M2016-0054 TR 1 Adequacy Review 3 Response

RE: Adequacy Review No. 2; Technical Revision (TR-1) – Revise Mining and Reclamation Plans and Maps to Account for Acreage Release Areas in AR-1; Irwin/Thomas Mine, Permit No. M-2016- 054

Please accept this letter and the included attachments as our combined response to your Adequacy Review No. 3 letter dated April 13, 2023. Our response follows your response as outlined in your letter as follows:

EXHIBIT C-4

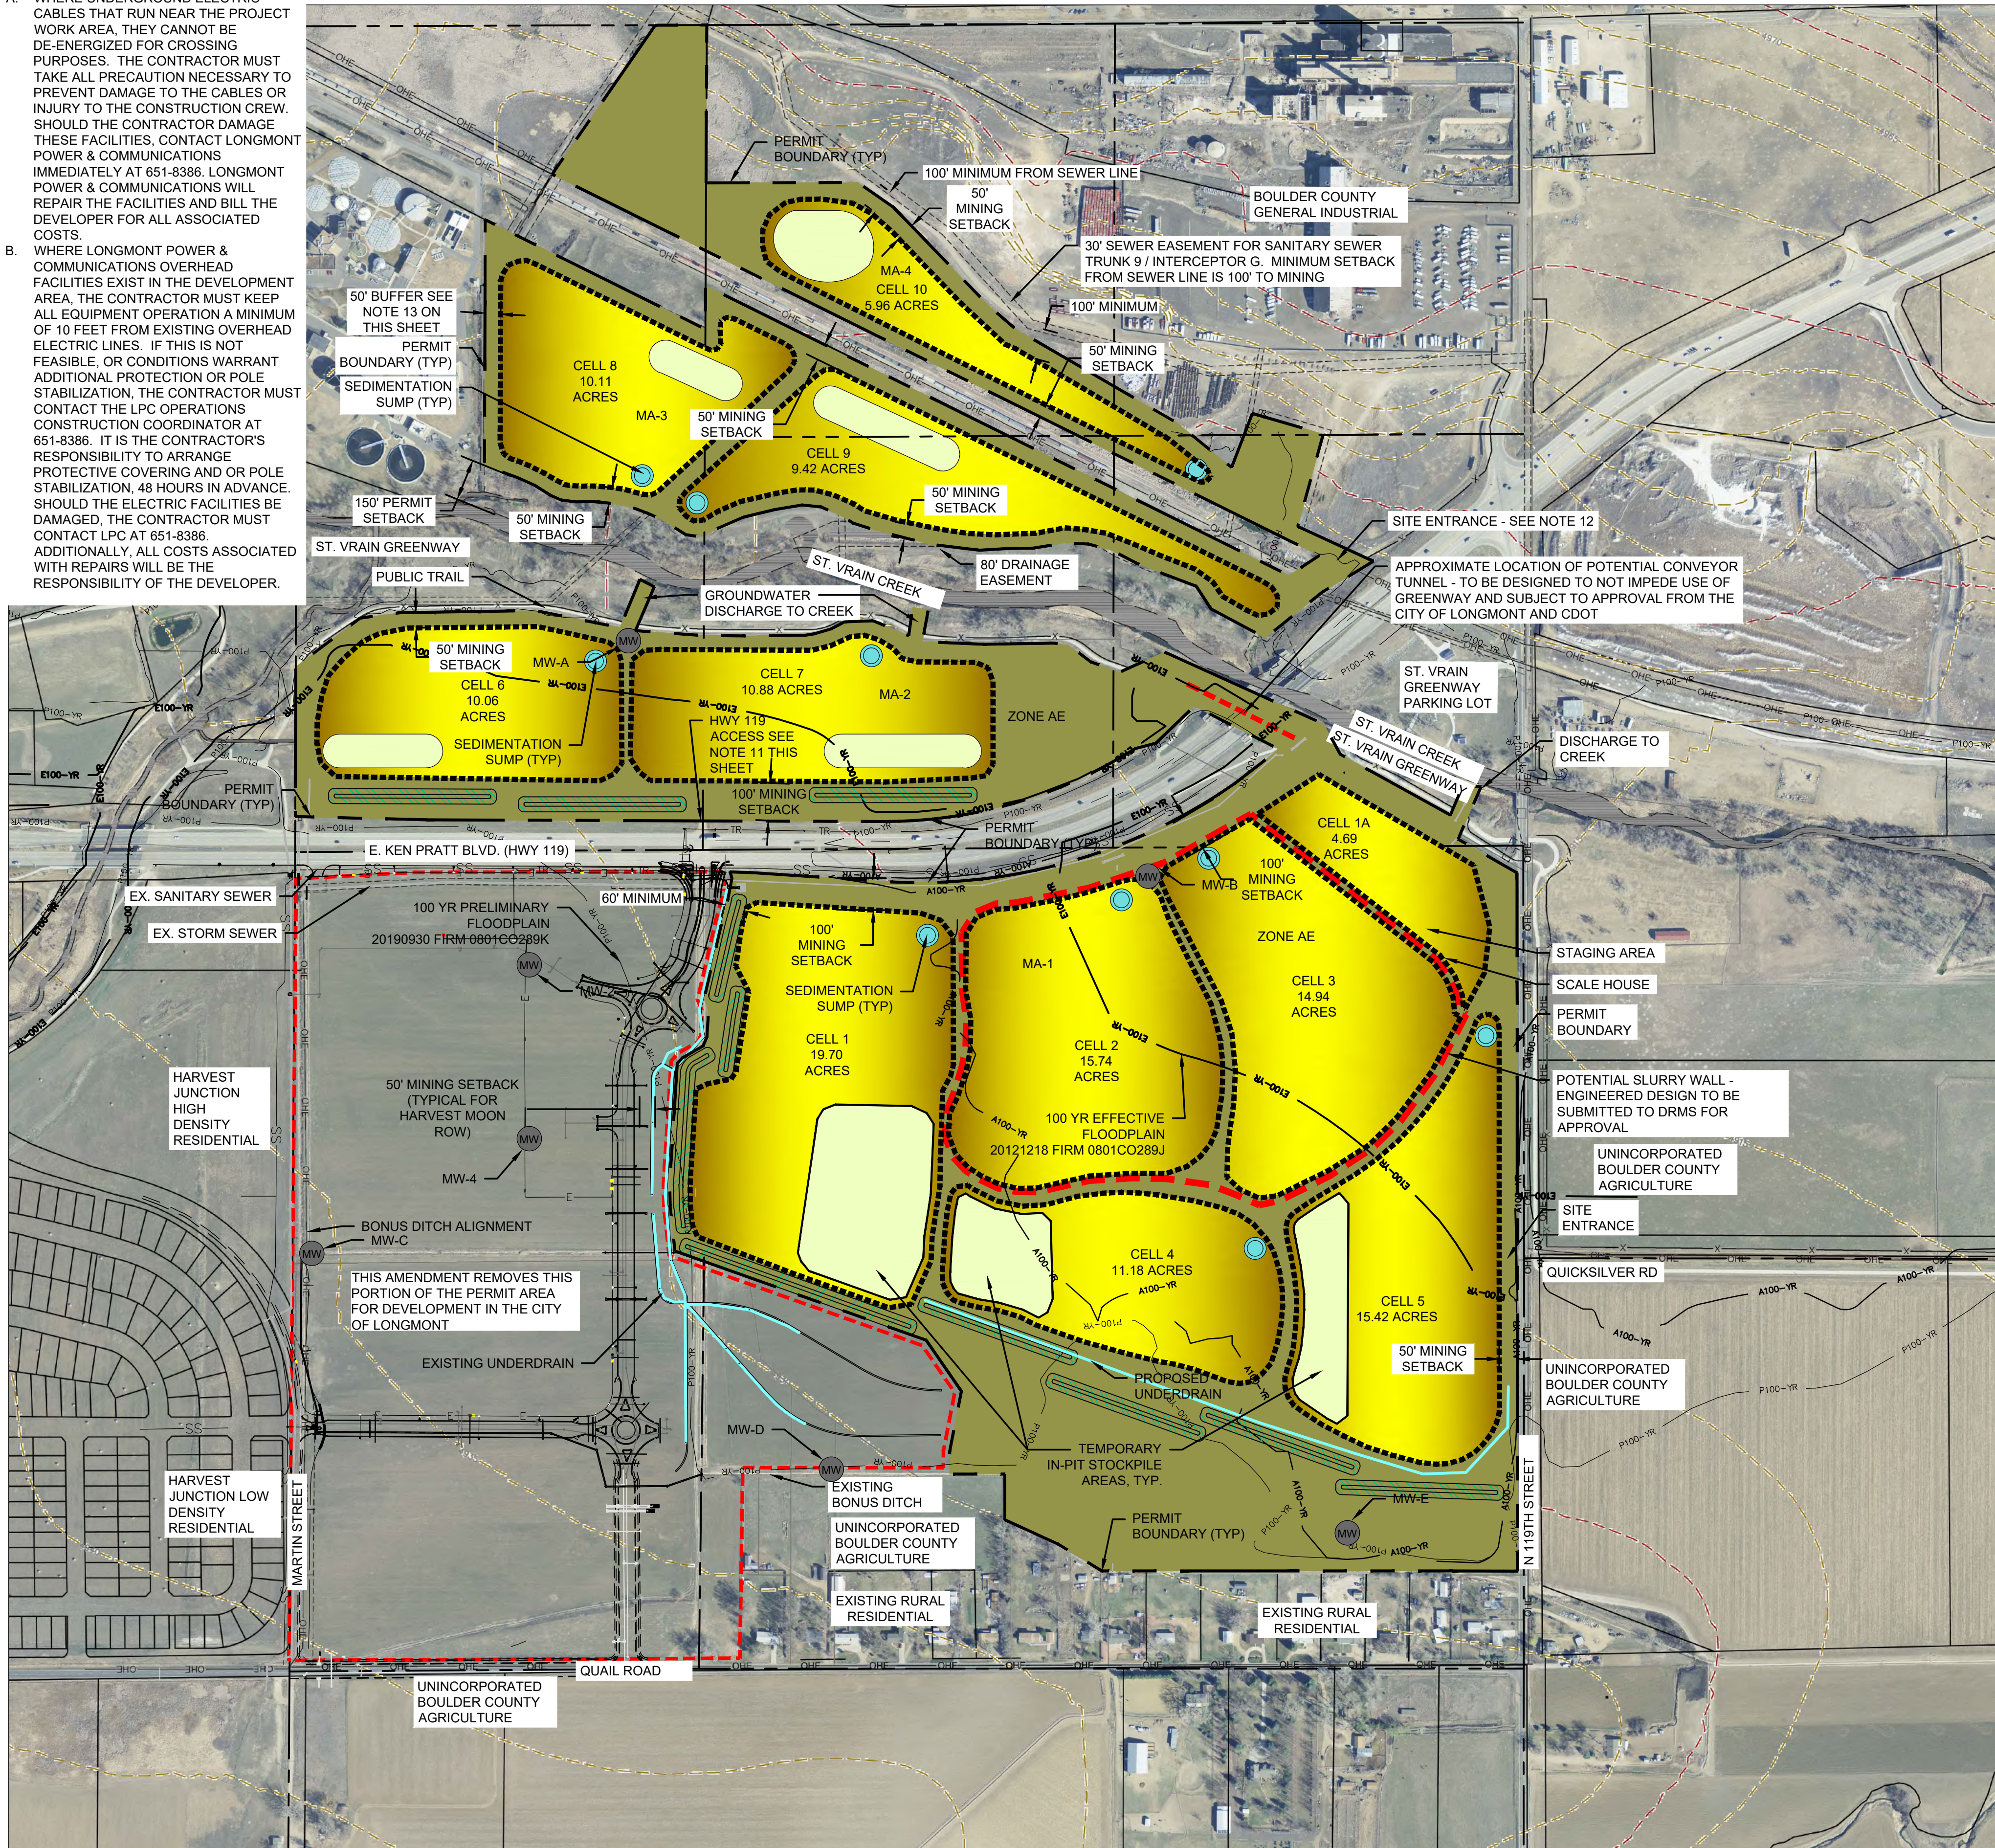
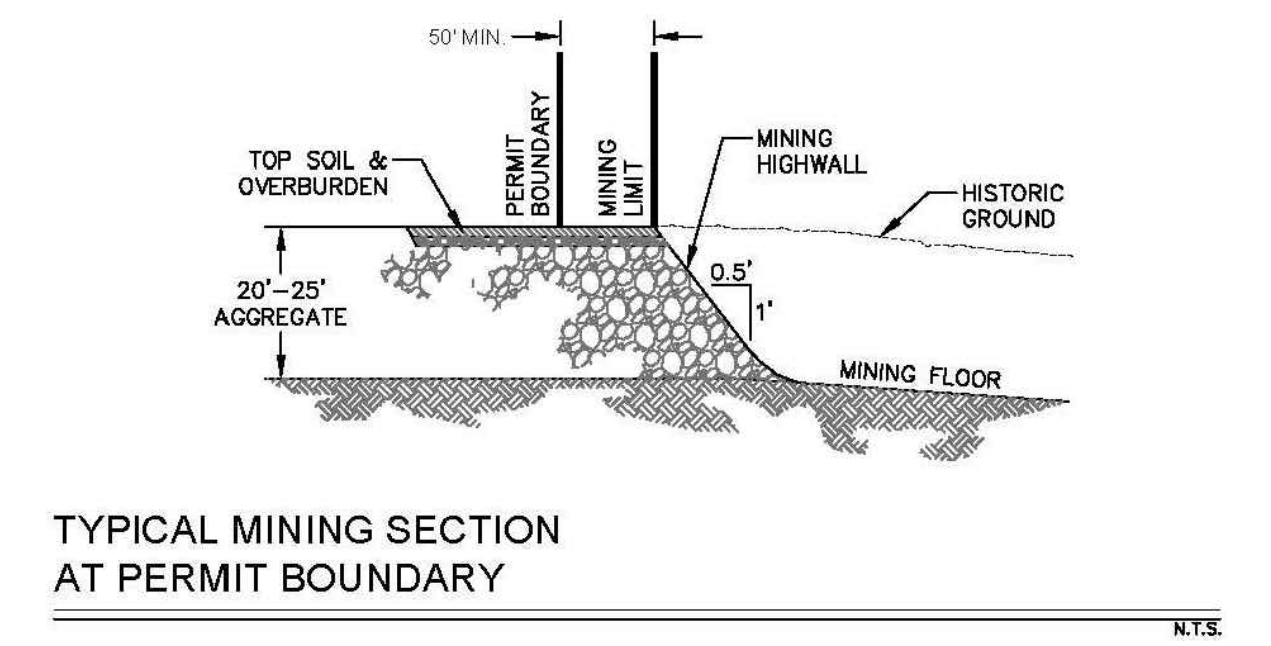
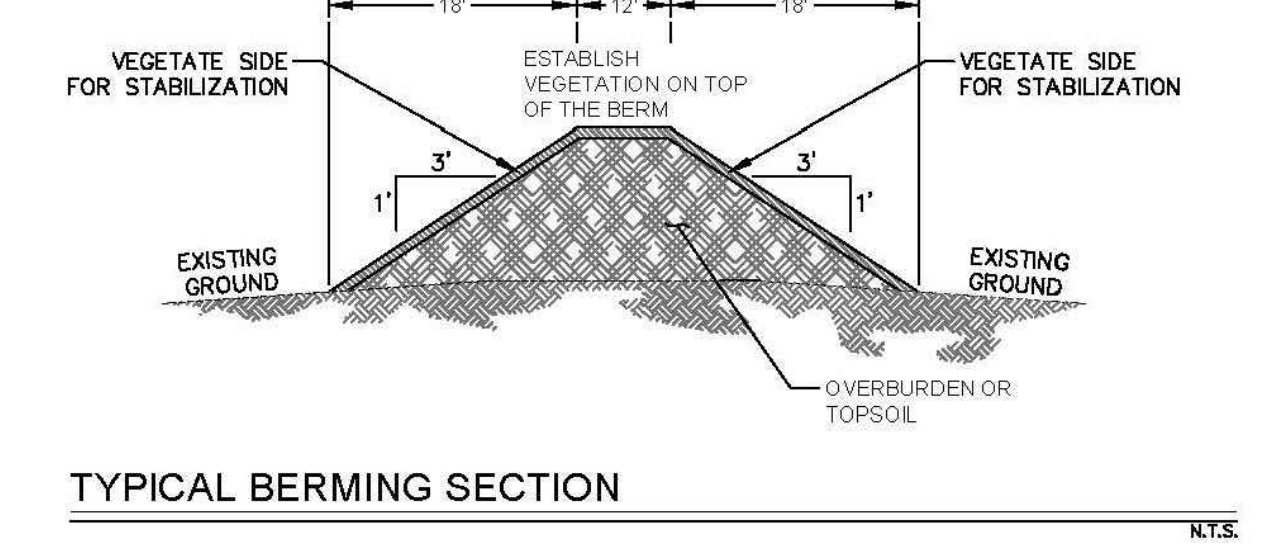
3. Additional clarification is needed regarding what order the cells of MA-1 will be mined. While it is stated in the Mining Sequence Notes of Map C-4 that Cell 1A will be mined first, does the Operator intend to wait until next year, as mining of Cell 1A is restricted to be between October and April, to begin mining at the site or does the Operator want to mine Cell 1 prior to mining Cell 1A. Please update the notes section according to the clarification given.

Applicant Response: At this point, Cell 1 will be mined before cell 1A as there is a limitation of mining within Cell 1A during the flood prone season of April through October. The operator will circle back to complete mining and backfill of Cell 1A at the end of October. Overburden excavated from 1A will be placed in Cell 1, the area within Cell 1A will be backfilled using overburden from Cell 1. Cell 1A will be backfilled and revegetated prior to the flood prone season beginning the following April.

TR1 AR-1 / AR-2 AREA MAP

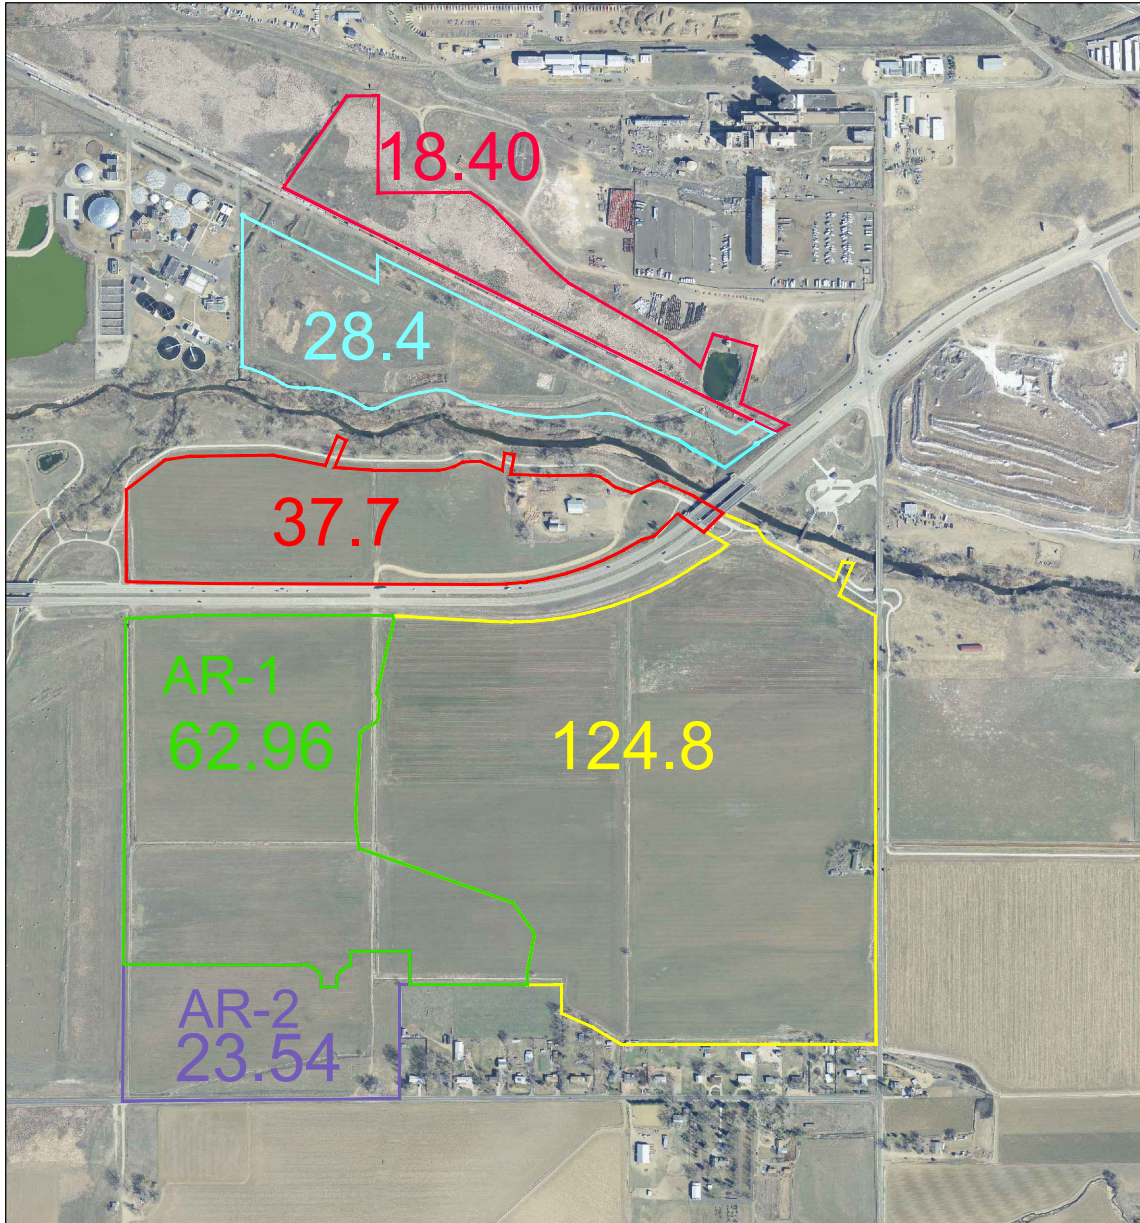
From the table above there is an overall difference of approximately 21 acres between what the Operator has calculated and what the Division has calculated. Please see Attachment 1 for a map the Division used to estimate the areas. It appears AR-1 did not fully account for the acres intended to be TR-1 released. The Division estimates the area to be released in AR-1 should have been approximately 84.8 acres not the 62.96 acres that were released. The Operator may have to submit another acreage release request before TR-1 can be approved. Please provide a discussion on the discrepancies reflected in the table above.

Applicant Response: Please see the updated table above. The acreage in AR-1 was incorrect. We will submit AR-2 to make the Permit Boundary match the acres that should have been released with AR-1. There is no mining activity taking place within the area associated with the land development to the west. The area included within the land development to the west includes 86.5 acres. The applicant will prepare and submit AR-2 to remove the remaining 23.54 acres from the permit area. We request that TR-1 can be approved conditioned on submitting the application for AR- 2 and the applicant can begin mining while AR-2 is being processed. Please see Attachment 3 – Permit Area Exhibit.
